CITY OF NORTH OAKS

**Regular City Council Meeting
Thursday, July 08, 2021
7 PM, Via Teleconference or Other Electronic Means Only
MEETING AGENDA**

**North Oaks City Council
Special Meeting Minutes
North Oaks City Council Chambers
June 10, 2021**

4a. Discussion on Anderson Woods Final Plat/Plan

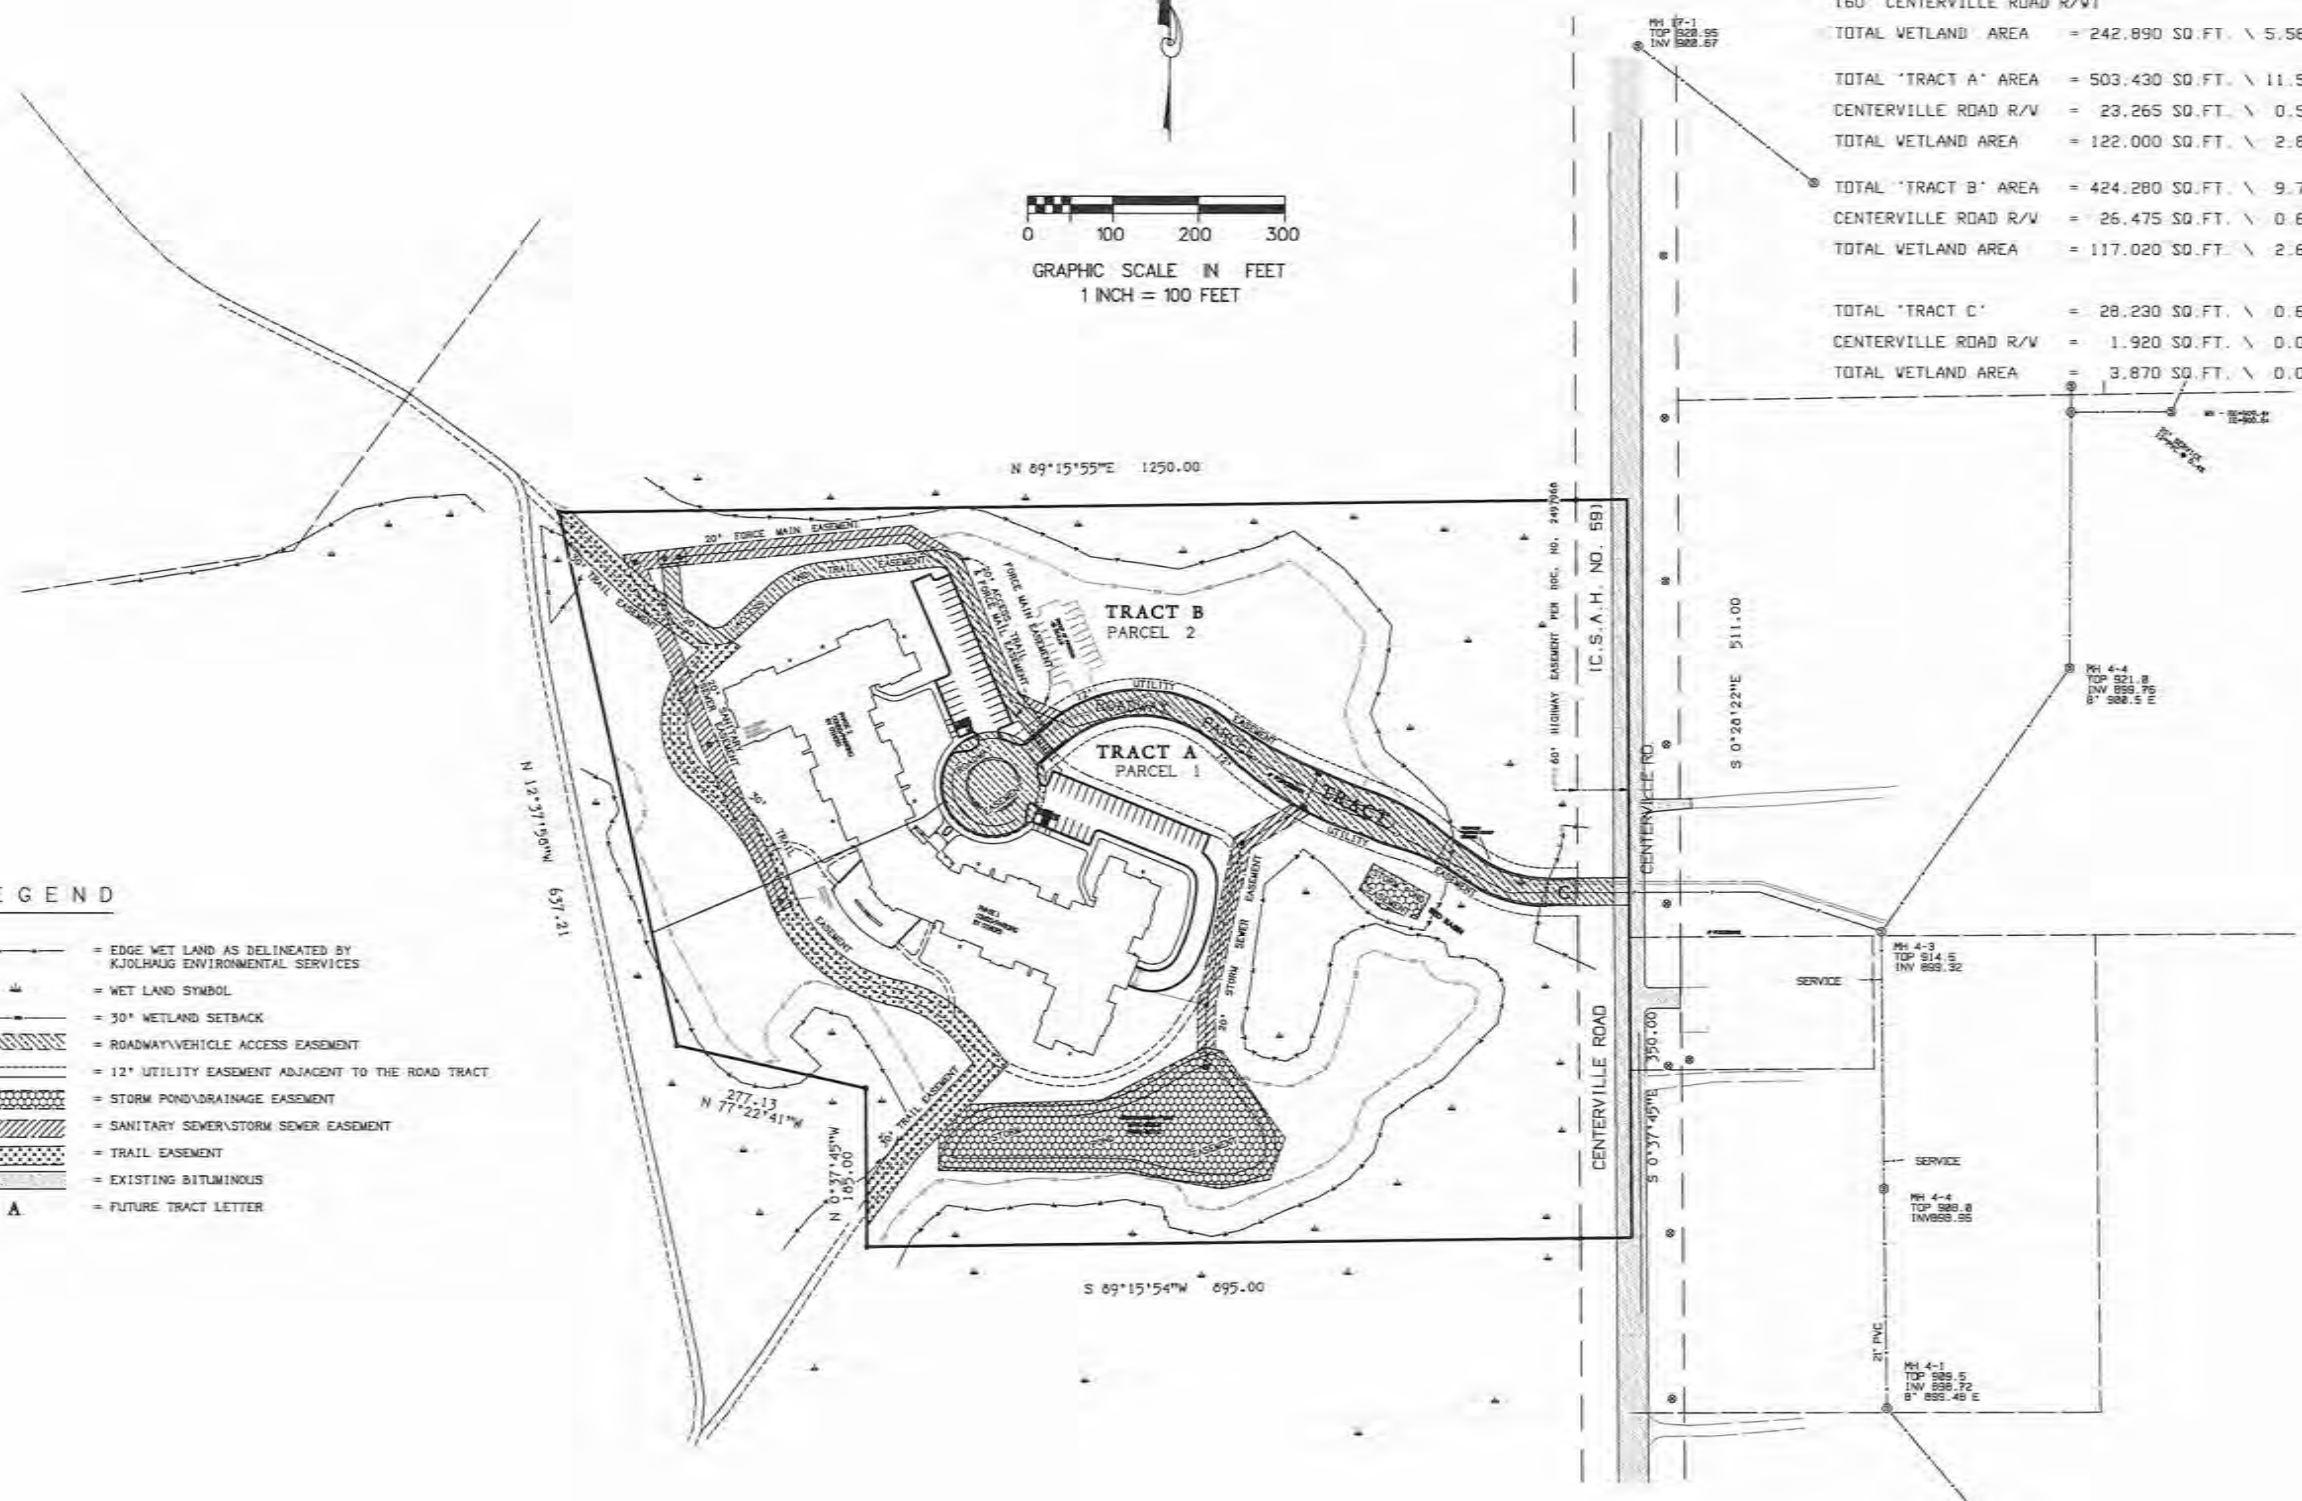
Mr. Morast noted on Sheet 3 a general note is that they have expanded the storm easement to ensure access and maintenance from the road easement to the ponds and storm water facilities. On Sheet 4, the grading plan, comment 32 and 33 noted that the walkout elevations on Lot 5 were lower than the pond high water level and to make sure that is addressed.

Exhibit J: Final Grading and Erosion Plan

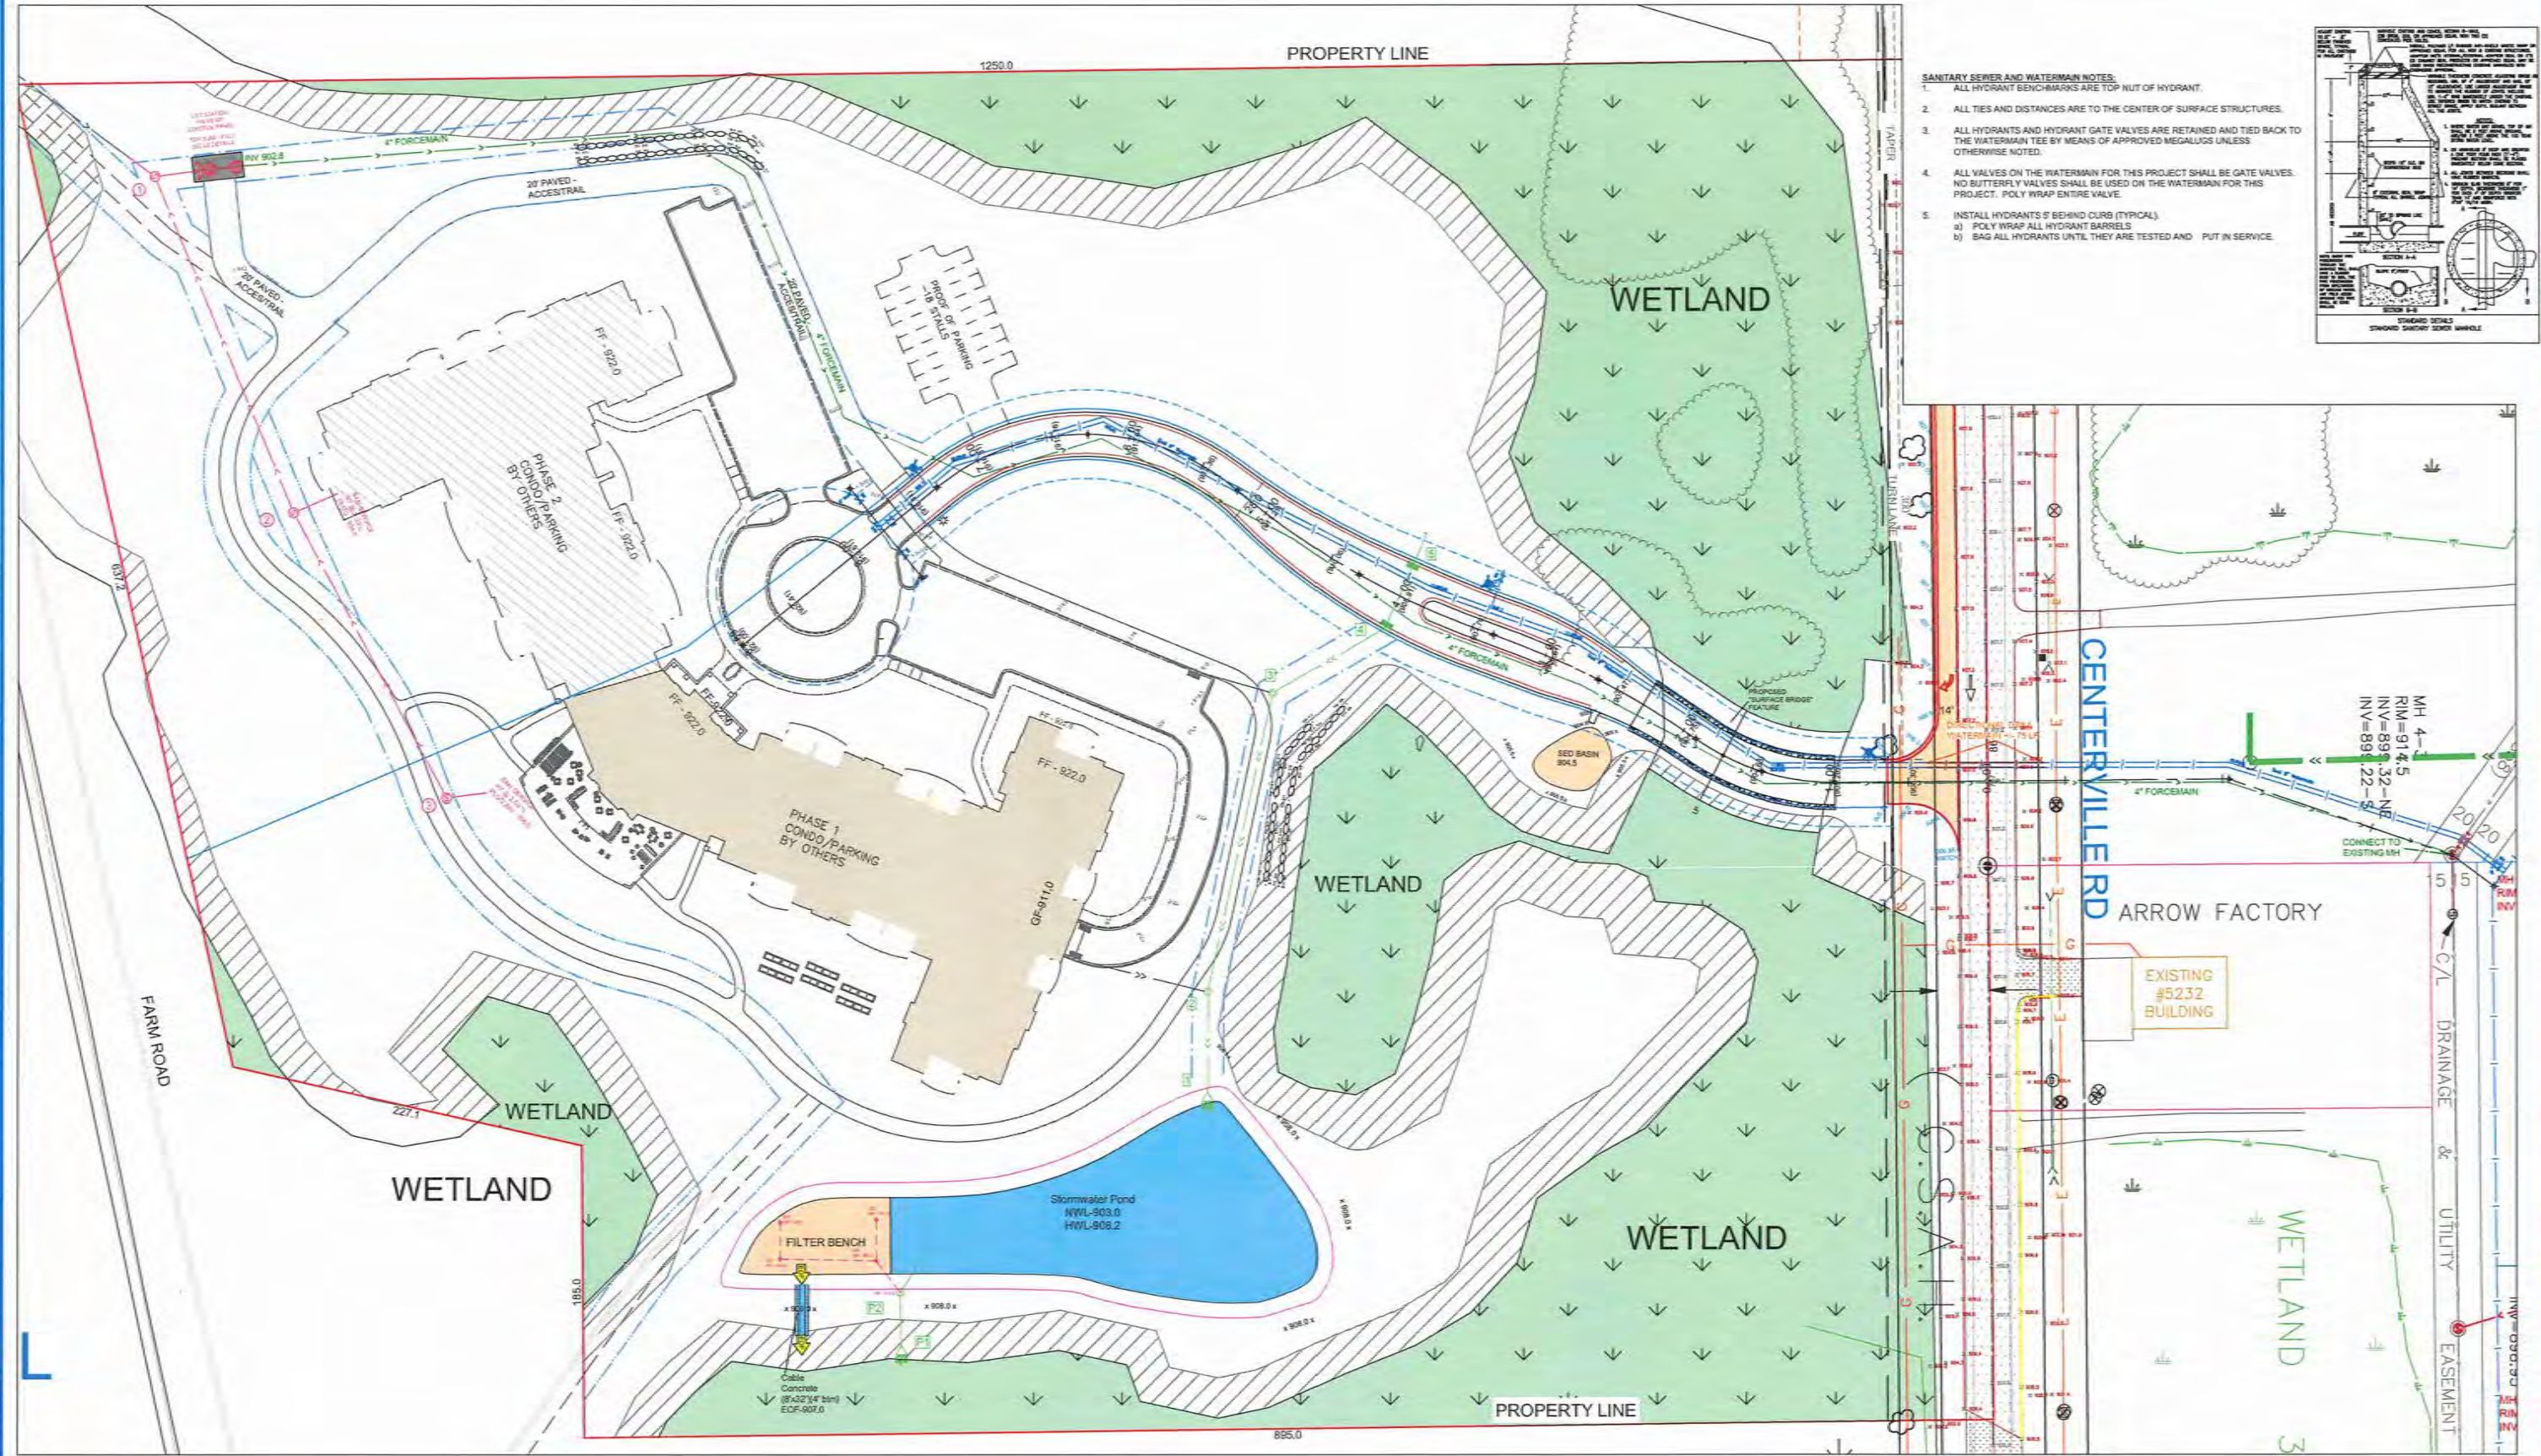
Mr. Morast continued his report on Sheet 4A which is the Final Erosion Control; there was a potential in the design for things to get clogged and he wants to clarify and change those. On Sheet 5 Sanitary Sewer and Water Main plans, the three force main pipes coming up from the cul-de-sac are actually in the road and crossing property lines, and he wants to clarify easements, ownership, and who is responsible for what, as well as provide some separation for the service lines. Regarding storm water plans, they suggest having a sump to keep sediment out and keep it at a little bit higher level of water quality.

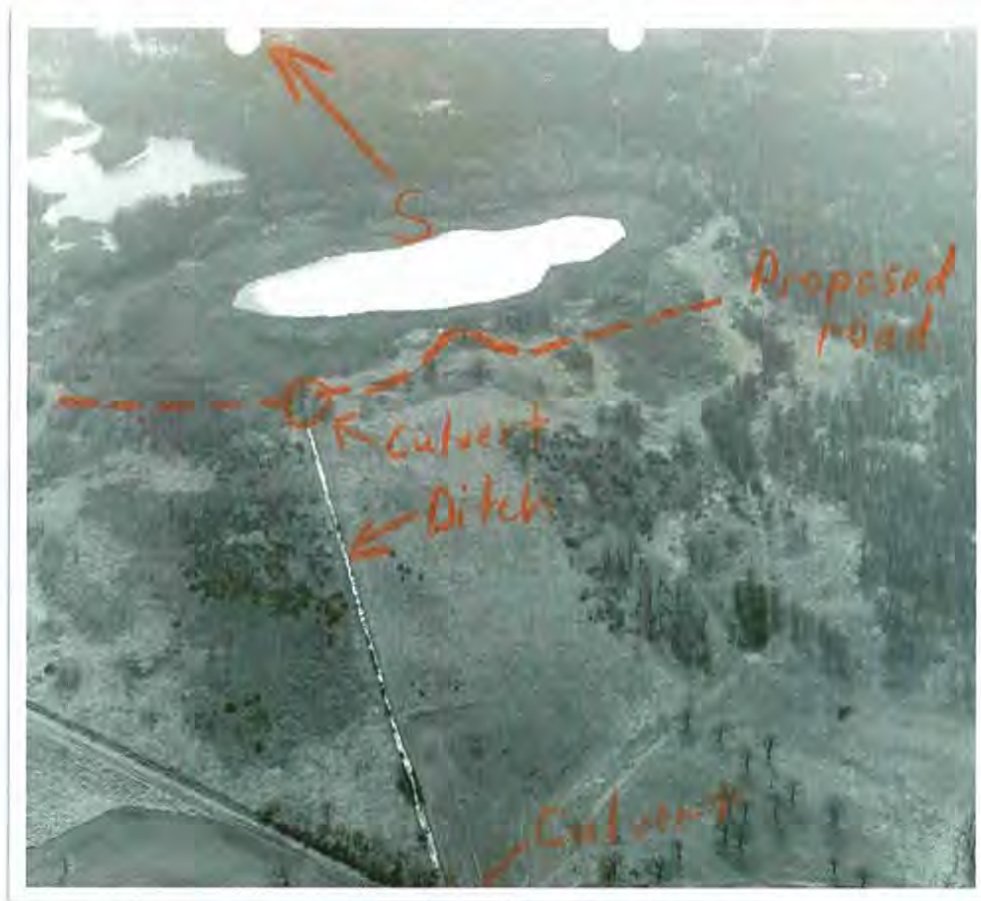
We respectfully retract our guidance from the December 16, 2020 letter regarding the northern boundary of Black Lake. Since that time we discovered several documents indicating that the northern edge of Black Lake is near the edge of the farm road trail (Figure 1). The documents are the August 24, 1987 memo from Kent Lokkesmoe; the field notes from the 1987 OHWL survey; the permit file for permit #1987-6751; 1999 PUD review documents provided to DNR and subsequent DNR comments in support of the East Oaks PUD proposal, which showed a northern boundary of Black Lake near the southern edge of the farm road trail.

We were correct in the 2020 DNR letter in advising that (OHWL) for Black Lake is 899.4 ft (NGVD 1929). That elevation can be used in delineating the precise northern boundary of Black Lake, which is south of the location of farm road trail and outlet culvert that intersect the farm road trail (Figure 1).
